New Business Item No. 1

**AGENDA REQUEST
BUSINESS OF THE CITY COUNCIL
CITY OF PEARLAND, TEXAS**

AGENDA OF: October 13, 2014	ITEM NO.: Ordinance No. 2000M-117
DATE SUBMITTED: October 6, 2014	DEPT. OF ORIGIN: Community Development
PREPARED BY: Lata Krishnarao	PRESENTOR: Lata Krishnarao
REVIEWED BY: Matt Buchanan	REVIEW DATE: October 7, 2014

Re: Recommendation on Zone Change Application No. 2014-02Z

Exhibit B4 Building Program Plan

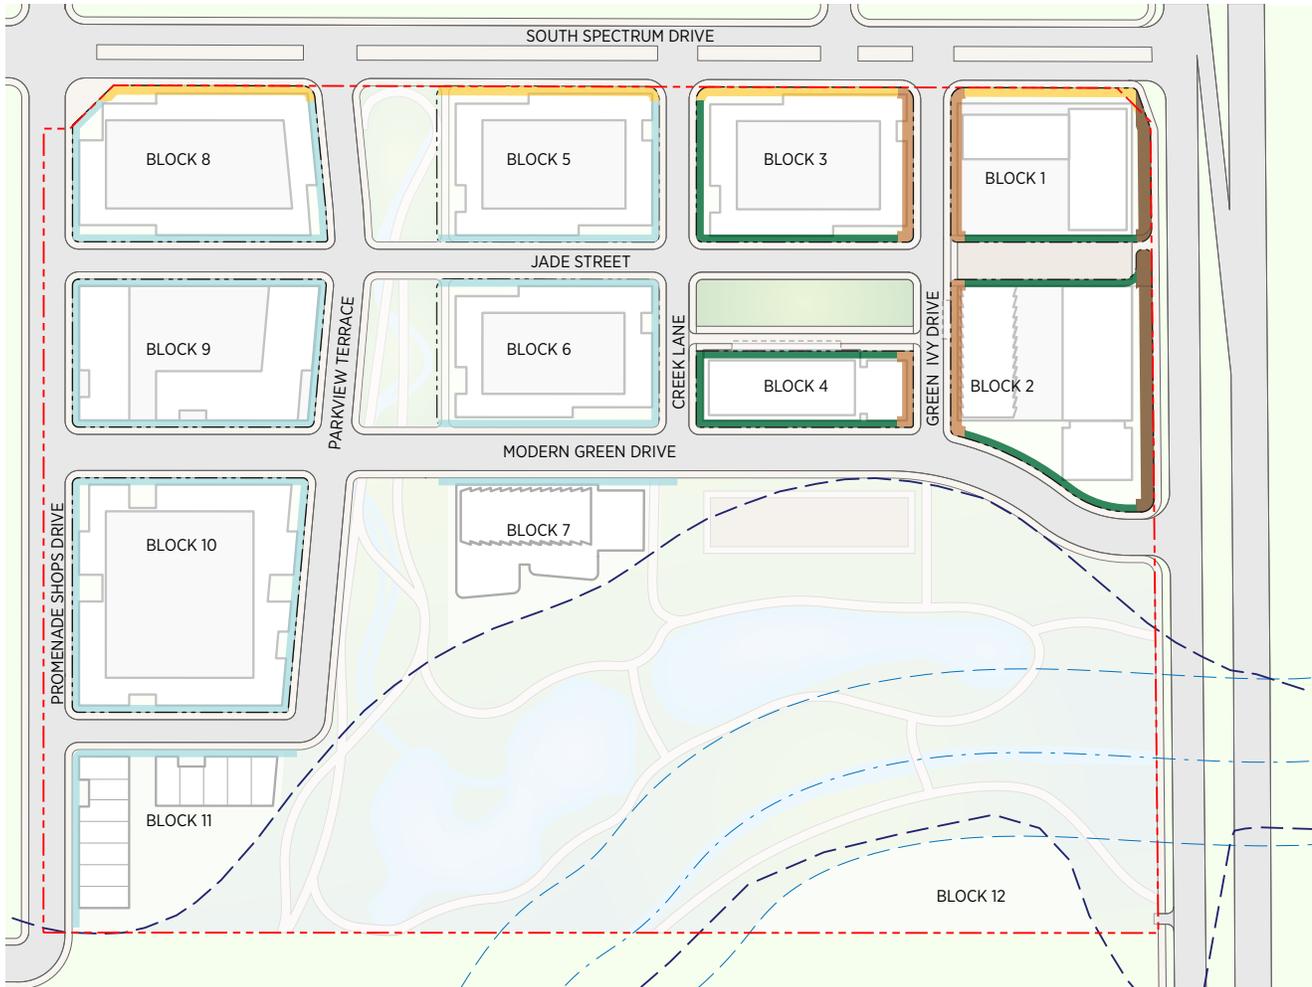
COUNCIL DISCUSSION AT THE FIRST READING ON SEPTEMBER 22, 2014: The zone change was discussed by the City Council at their first reading of the ordinance on September 22, 2014. At the first reading the applicant proposed changes to the Expected Program Density as shown in the table below in red text. The changes included the following:

- a. Office use increased from a minimum of 140,000 square feet to 200,000 square feet.
- b. Residential component - individually owned units increased from 750 to 800 and rental residential units decreased from 400 to 350 units.
